**DEVIATION REVIEW
 AND DECISION FORM**

Monument Academy - Deviation No. 1
4-30-19

Monument Academy - Deviation No. 2
4-30-19

**Monument Academy - Deviation No. 3 (Pinehurst Circle)
 4-30-19**

Figure 2
**Phases 1 and 2
Site Plan**
Monument Academy (LSC #184820)

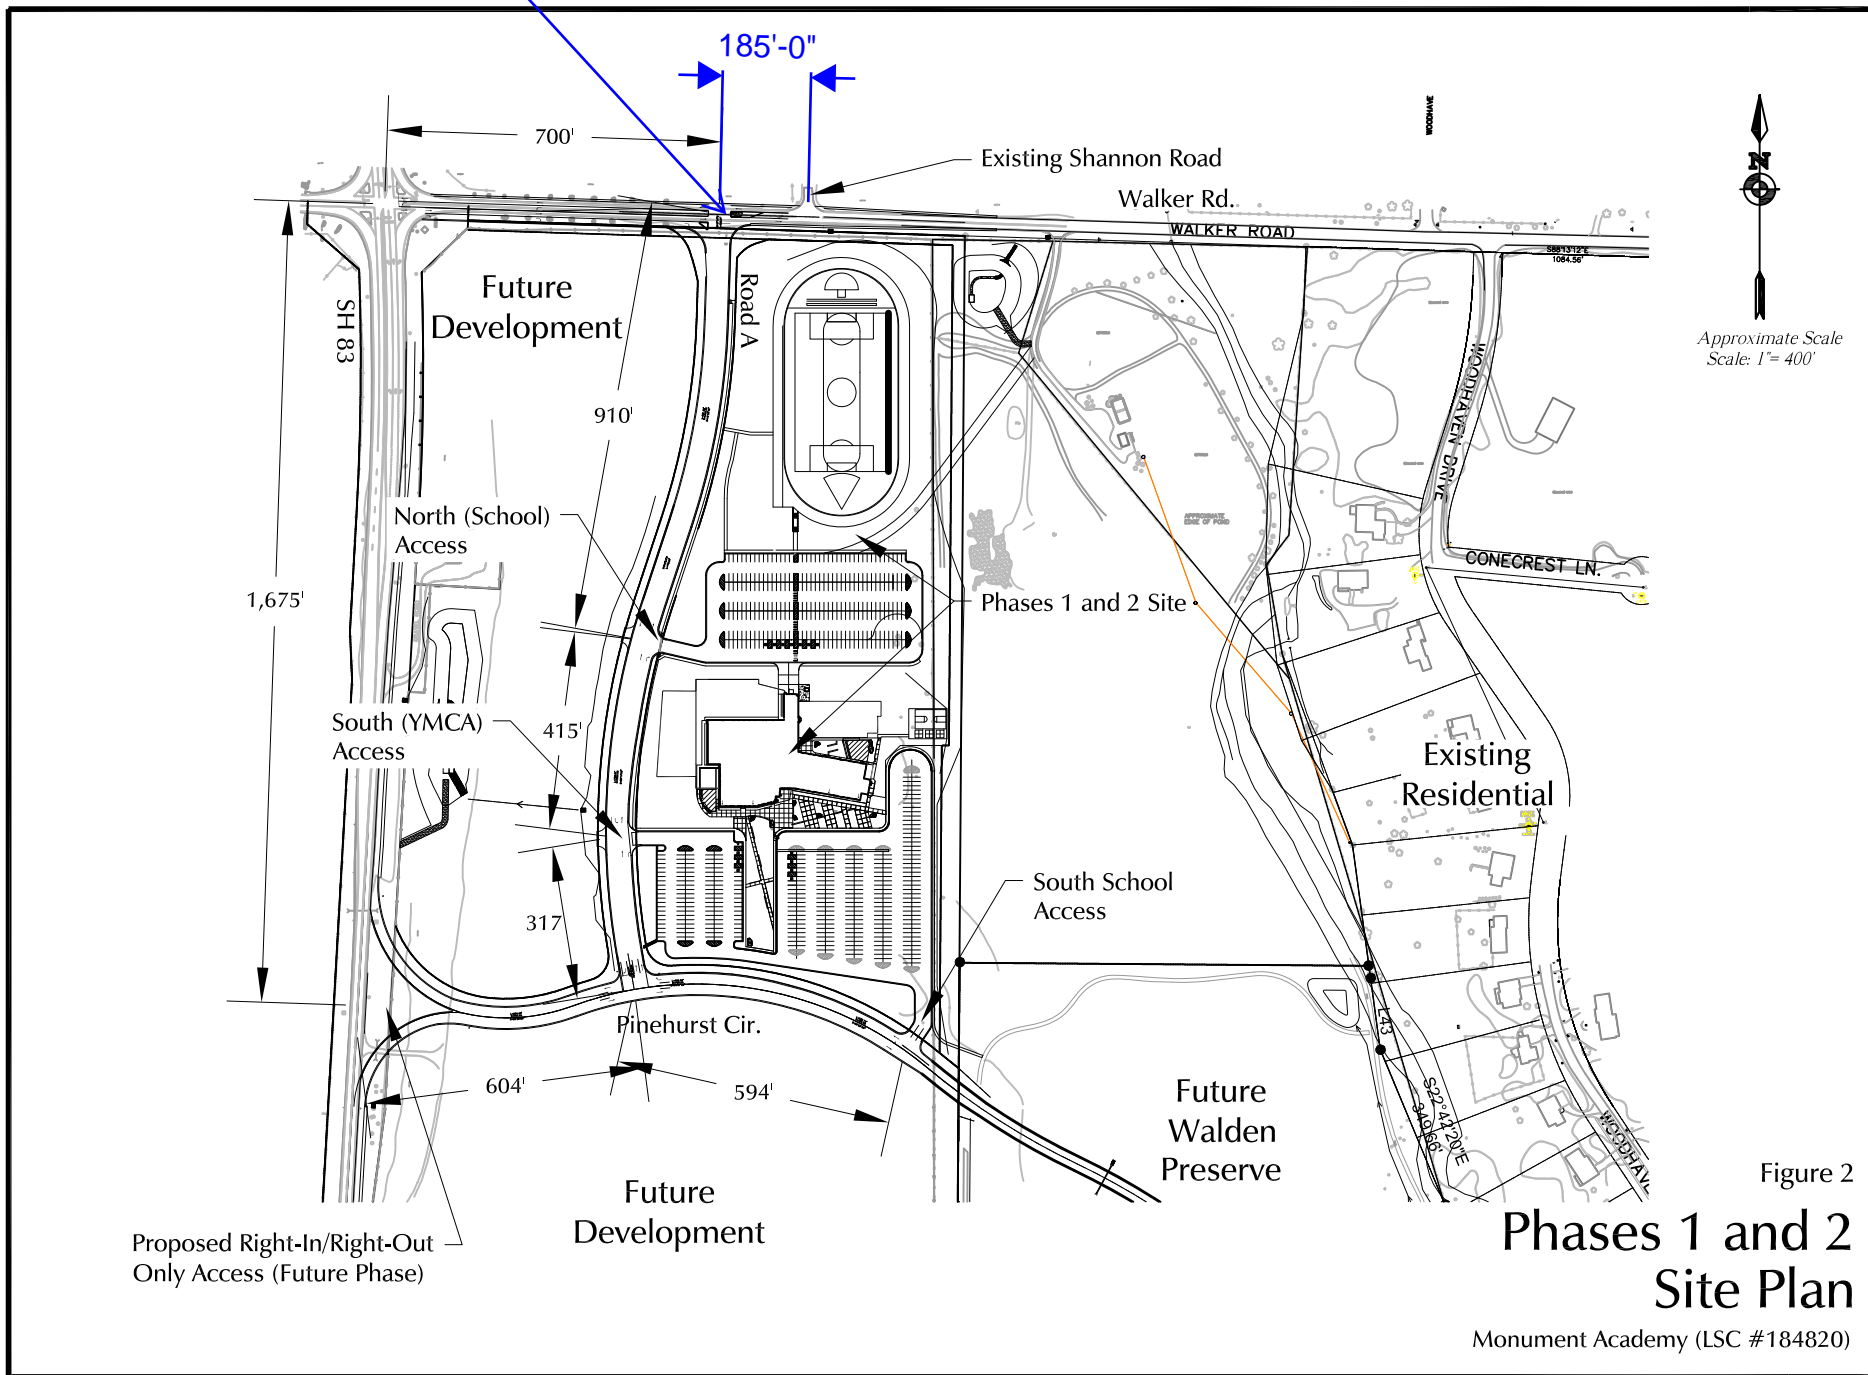
Provide deviation requests for non-standard cross-sections (half rural half urban) or revise plans. See TIS comments.

WB left turn lane to site?

Figure 2
**Phases 1 and 2
Site Plan**

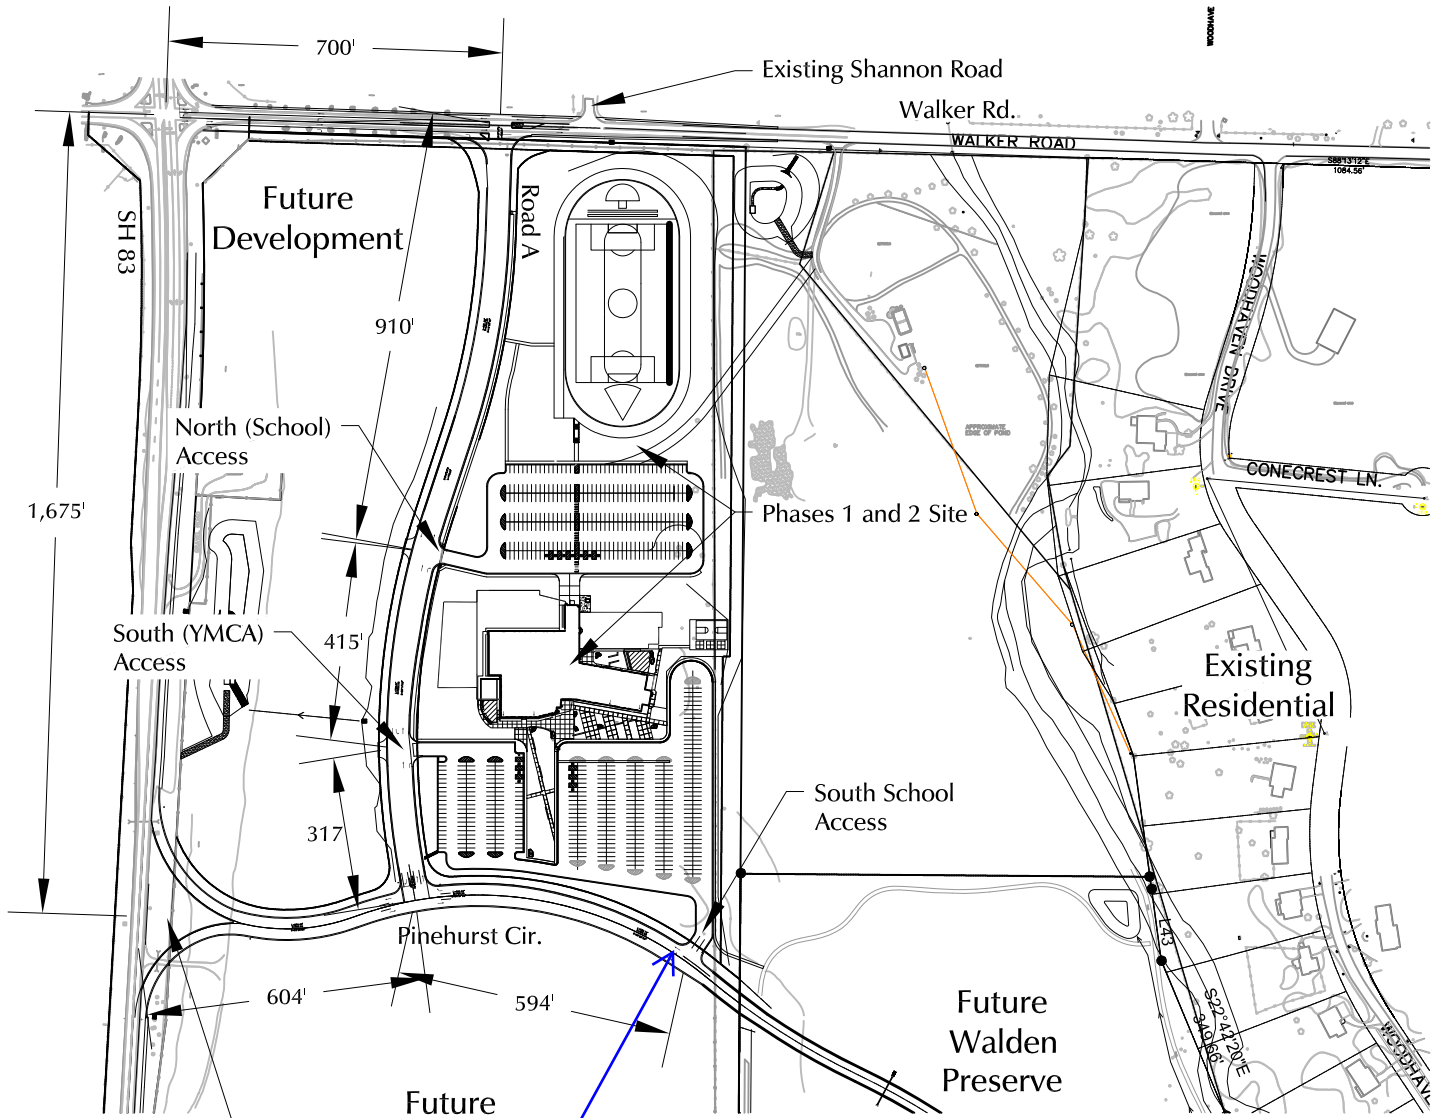
Is lower posted speed an option?

EB / SB left turn
lanes?
